**CITY OF AUSTIN – TRAVIS COUNTY – SINGLE SUBDIVISION OFFICE
SUBDIVISION APPLICATION – MASTER COMMENT REPORT**

CASE NUMBER: C8J-2023-0081
UPDATE: U0
CASE MANAGER: Sue Welch

PROJECT NAME: Manor Downs Industrial Preliminary Plan
LOCATION: 8916 HILL LN

SUBMITTAL DATE: May 15, 2023
FINAL REPORT DATE: June 8, 2023

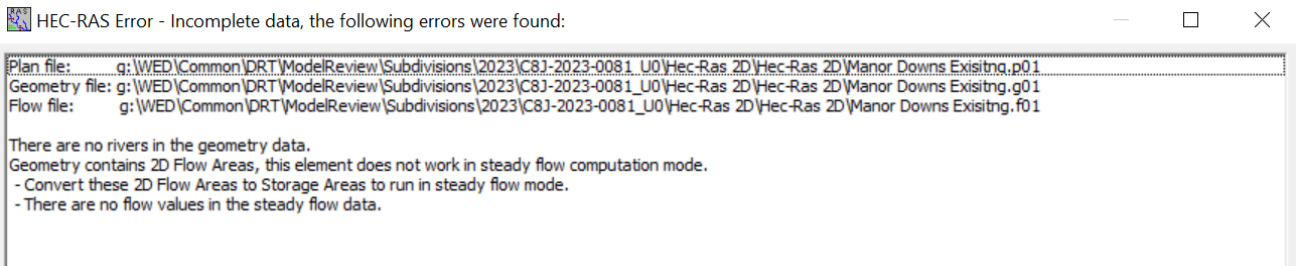
FYI: The HECRAS model that was provided is unable to run. See the screenshot below. It was attempted to run in RAS 6.3 as mentioned by the engineer. A 1D steady flow model is required for review to meet DCM code requirements.
